SERVICE LETTER

PEDAL FRICTION HARDWARE OPTION

MODELS AFFECTED: All McDonnell Douglas Helicopter Systems (MDHS) MD900 Series Helicopters.

Figure 1. Pedal Friction Hardware Change.

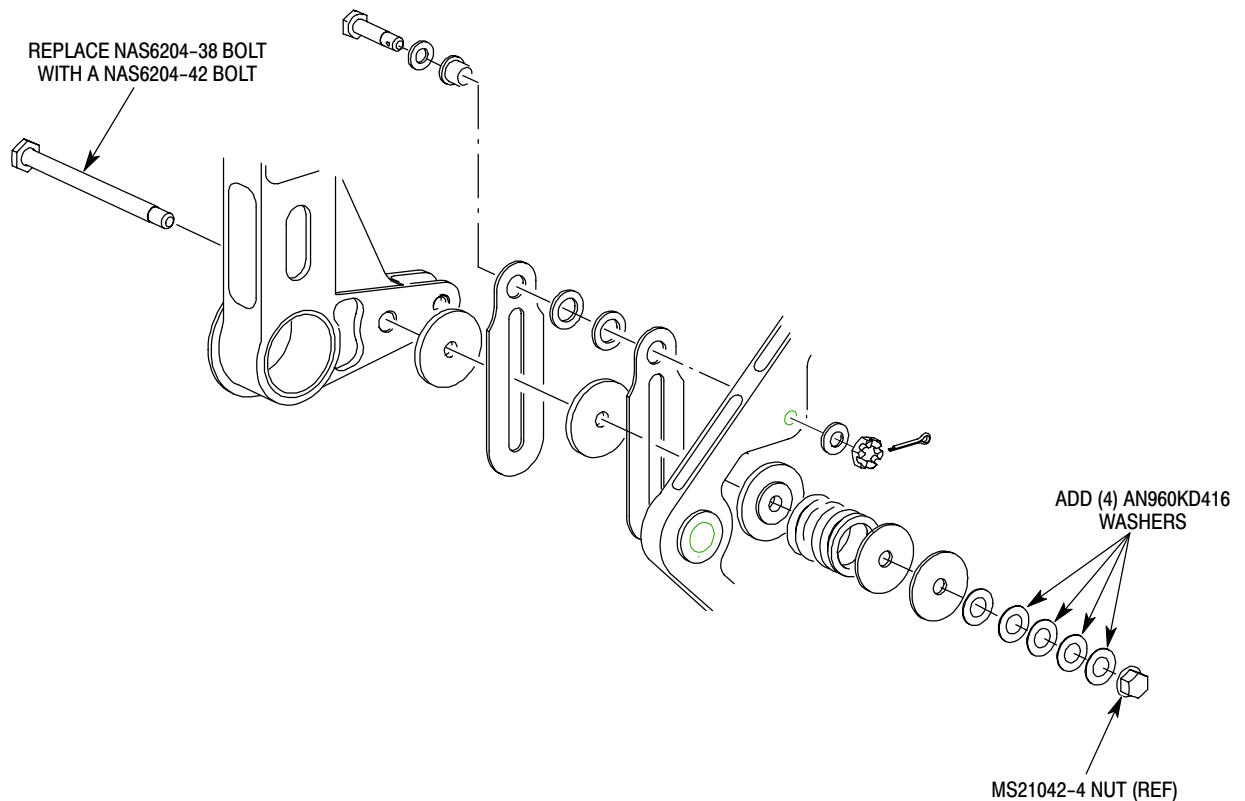
Operators are now allowed to make a change to MD900 pedal assembly hardware that will allow pedal breakout forces to be maintained by providing additional adjustment capability. The NAS6204-38 bolt may be replaced with a NAS6204-42 bolt. Additionally, four AN960KD416 washers must be added under the MS21042-4 nut as shown in Figure 1. Removal of any number of AN960KD416 washers is acceptable to achieve required breakout forces.
